President and Board of Trustees
Village of Arlington Heights
Board Room

October 19, 2015

Item: Ordinance - Chapter 28 Variation - Holy Nation Presbyterian Church

L-02

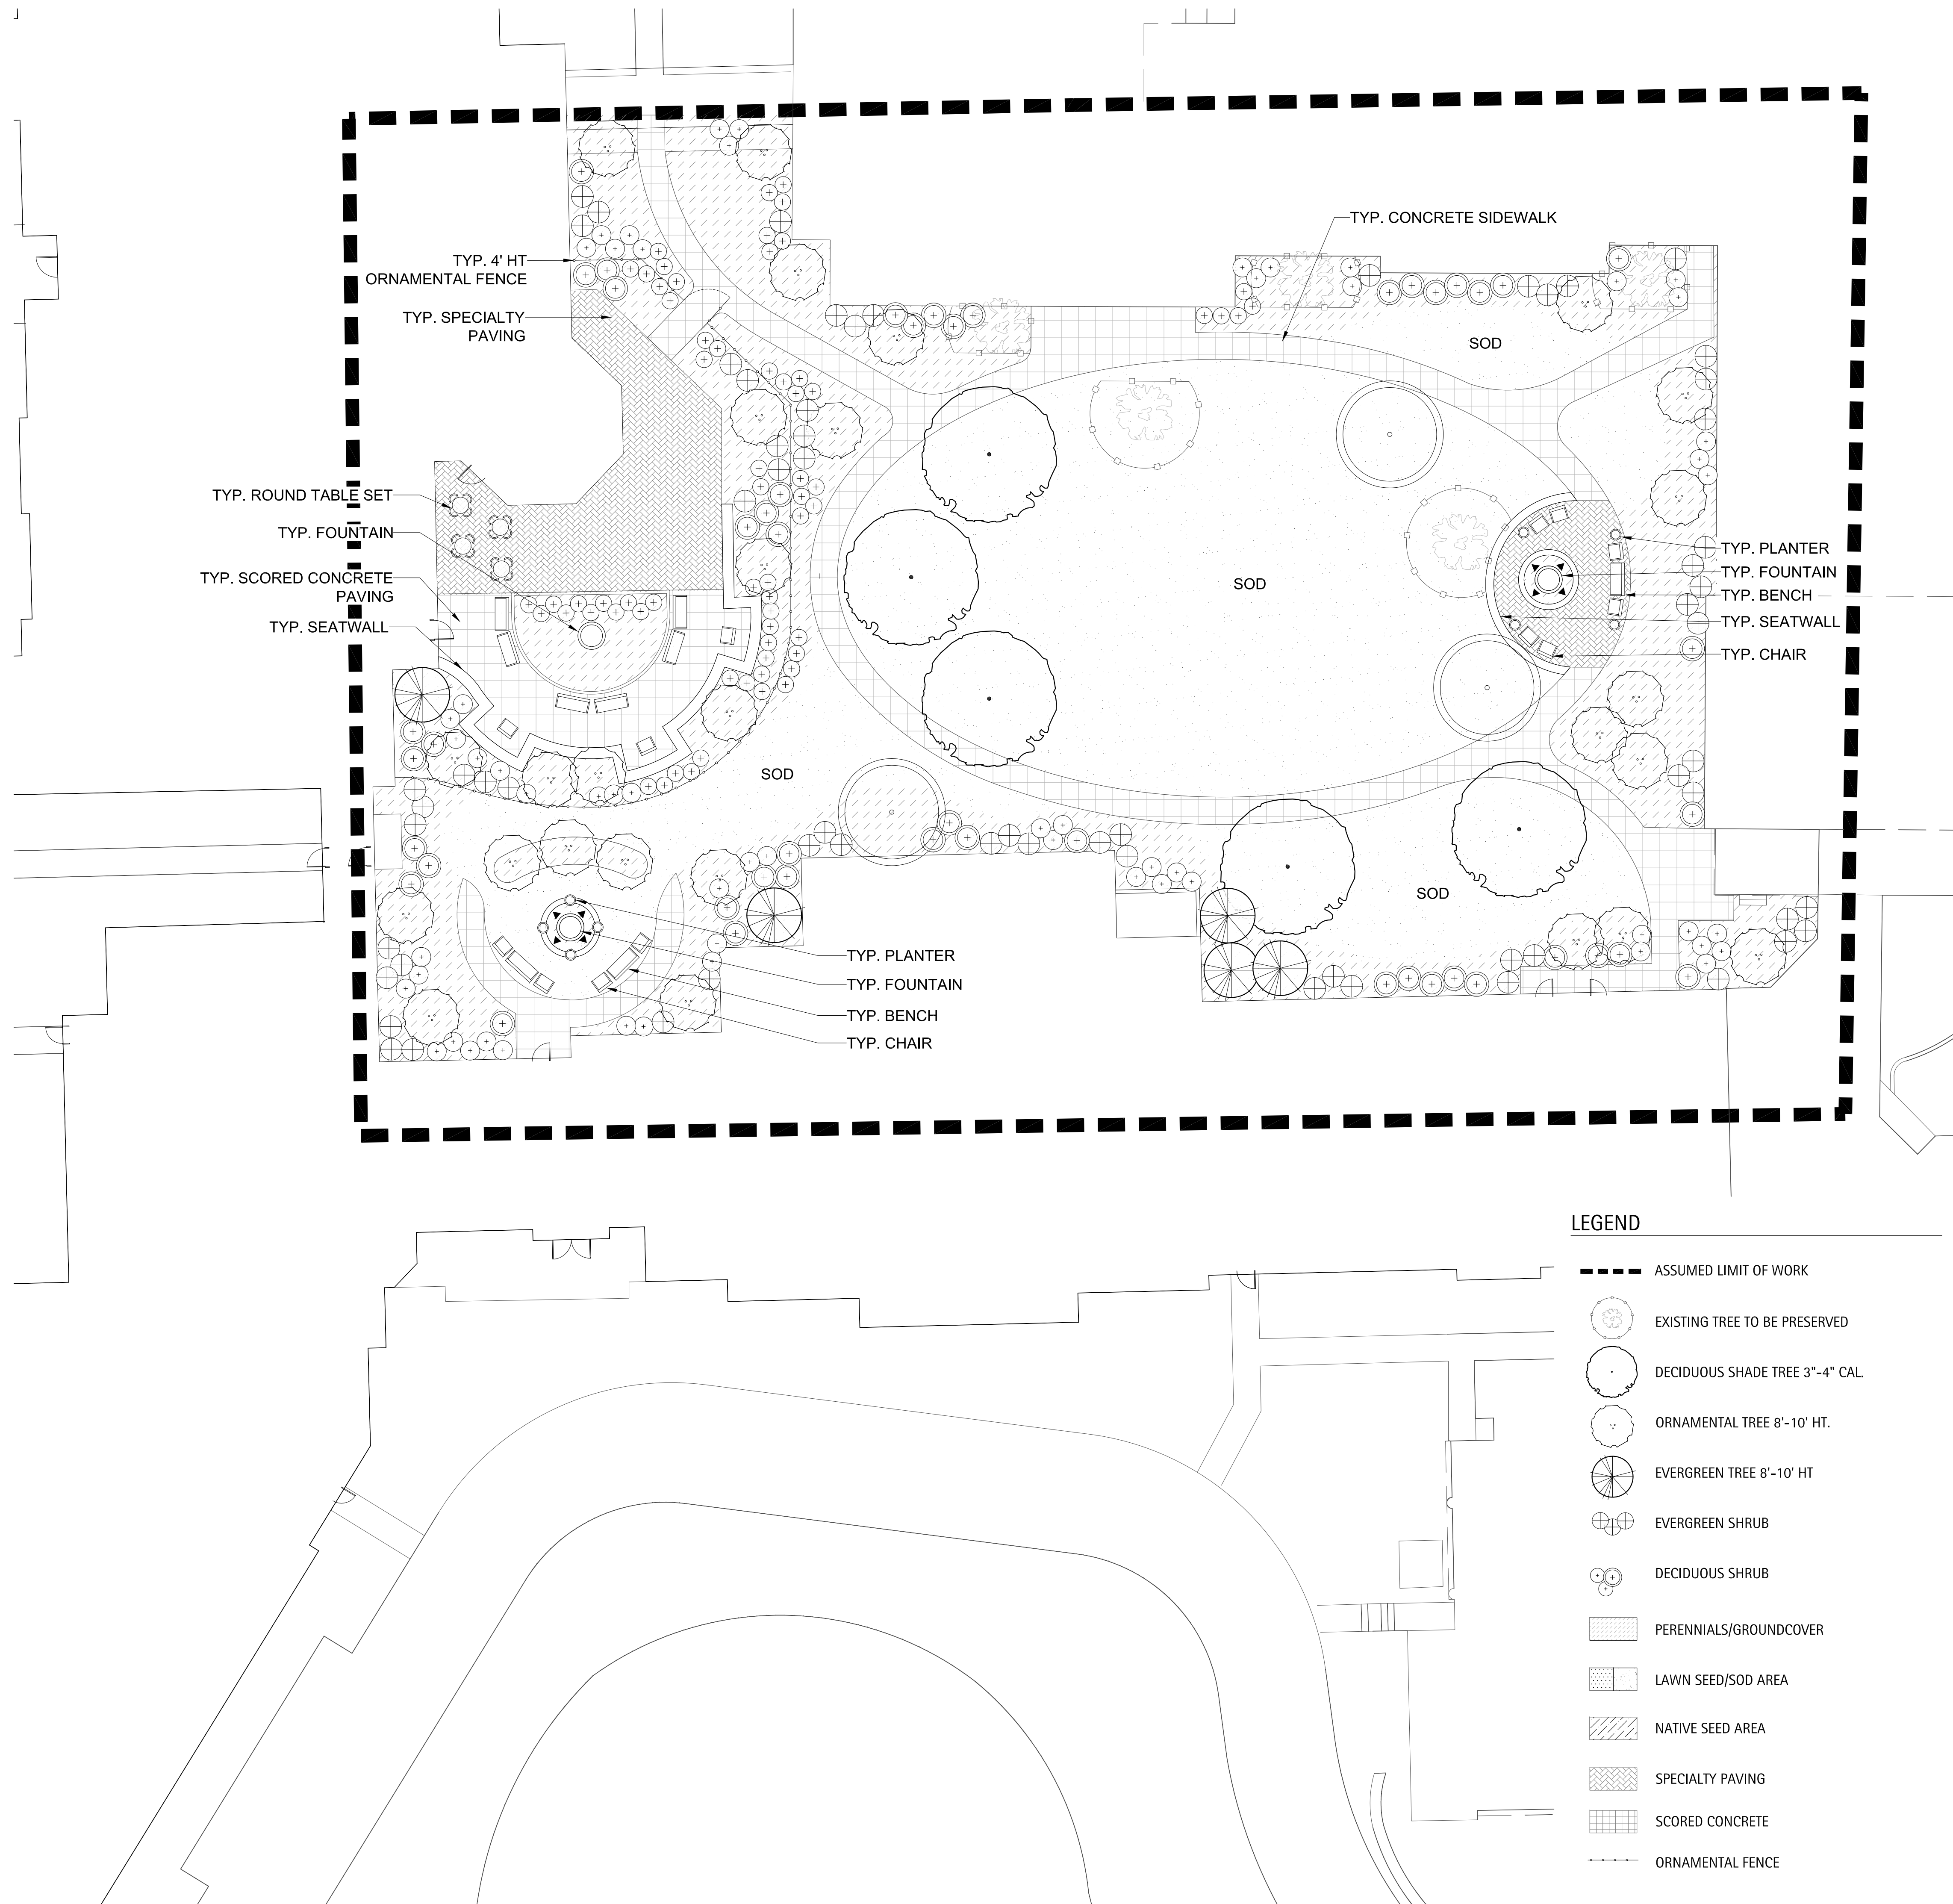
12. On Sheet L-02, the parking row on the west of the Memory Care Assisted Living is deficient 2 landscaping islands. Revise to include islands. Also, please clarify if there is a landscaping island at the south end of the east row of parking.
13. It appears that the opposing walls of inner courts are spaced at least 100 feet apart. Please confirm compliance with Section 5.1-8.11, Spacing between multi-family buildings, including court standards.

12. Sheet L-02 has been revised to incorporate landscaping islands that meet the standards set forth in the "Requirements for Landscape Approval" document supplied by the Village Planning Department. There is a landscaping island at the south end of the east row of parking. This island is shown on Sheet L-04.

- Additional trees have been added to the landscape plan at the south end and east end of the parking areas shown on Sheets L-02 & L-04.
- Landscape screening has been identified on Sheet L-04 and mechanical units have been located away from the front elevation.
